UNITED STATES PATENT AND TRADEMARK OFFICE

APPLICATION NO.	FILING DATE	FIRST NAMED INVENTOR	ATTORNEY DOCKET NO.	CONFIRMATION NO.
10/659,478	09/10/2003	Carl E. Yee	BSI-260US3	3432
23122	7590	05/11/2007	EXAMINER	
RATNERPRESTIA			PREBILIC, PAUL B	
P O BOX 980			ART UNIT	PAPER NUMBER
VALLEY FORGE, PA 19482-0980			3738	
			MAIL DATE	DELIVERY MODE
			05/11/2007	PAPER

Office Action Summary

1/9

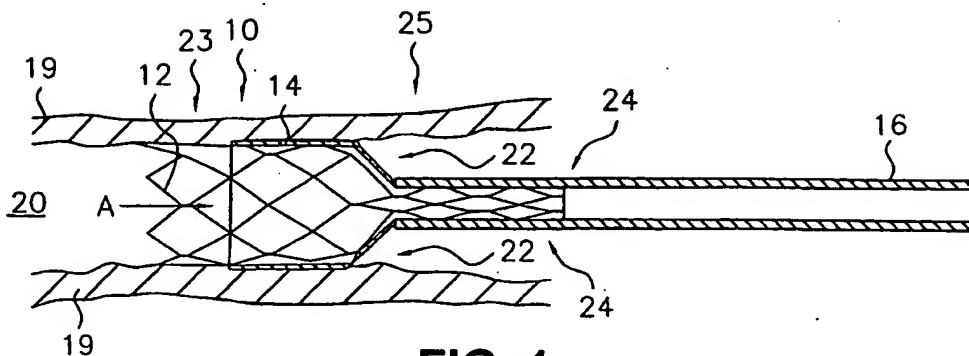
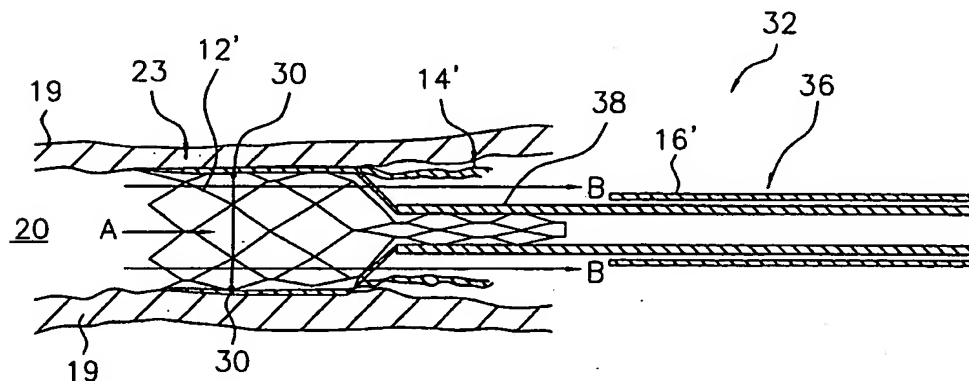
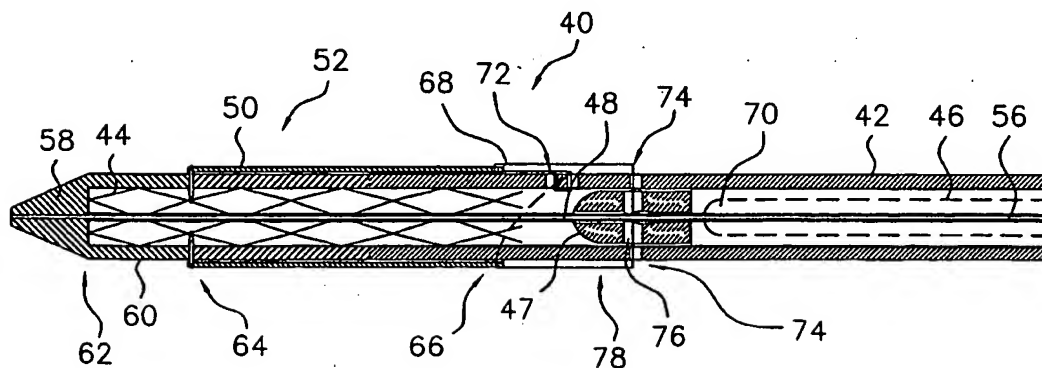
The proposed drawing changes filed July 24, 2006 have been approved with respect to replacement page 1/9 that corrected the lead line of reference number 68. However, replacement page 6/9 has not been approved because reference number 50 appears to now point to the blood vessel and not to the graft as it should.

Approved
 for
 Entry
 PBP
 5/9/07

6/9

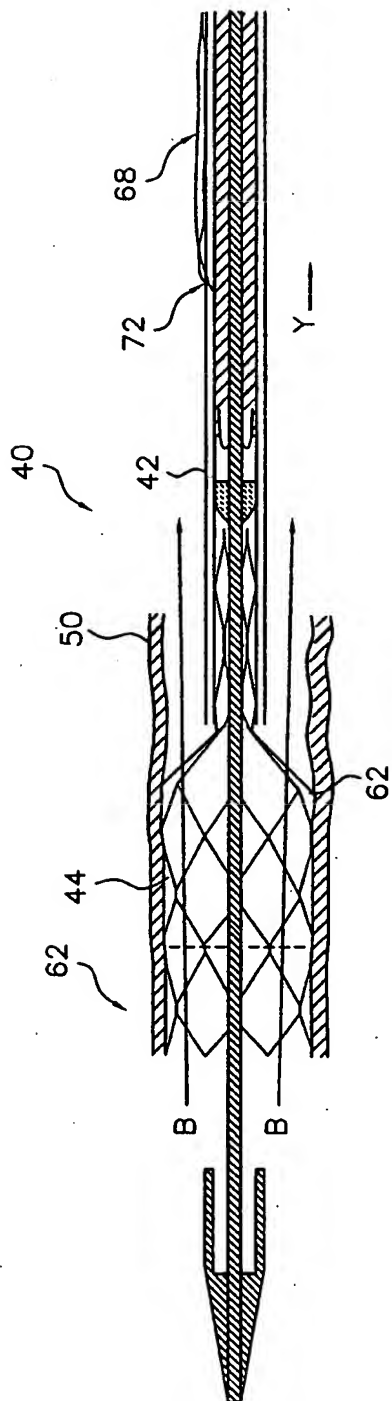
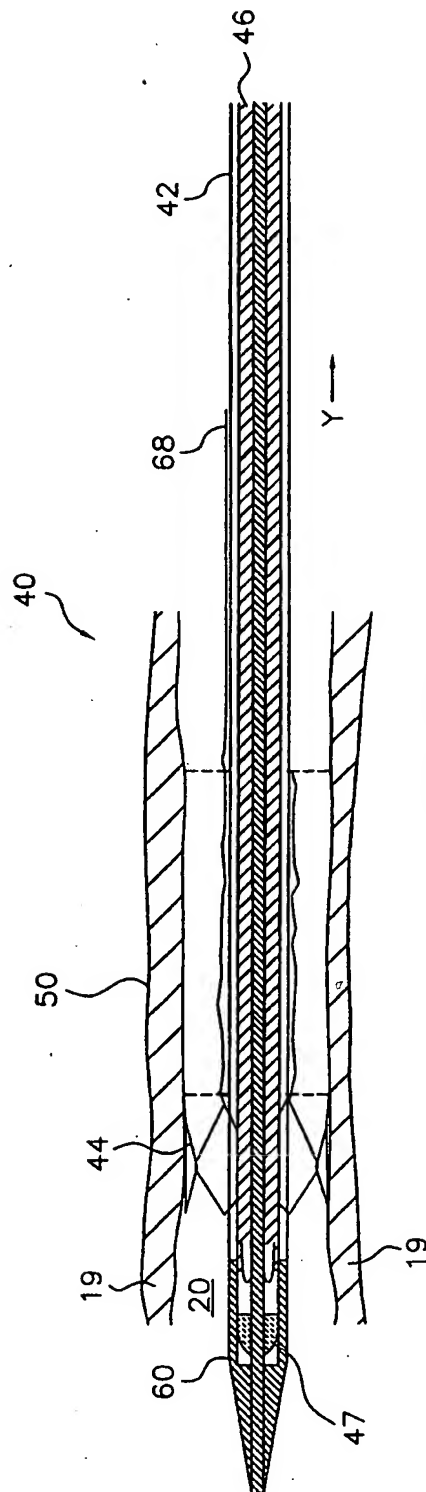
Not
 Approved
 for
 Entry
 PBP
 5/9/07
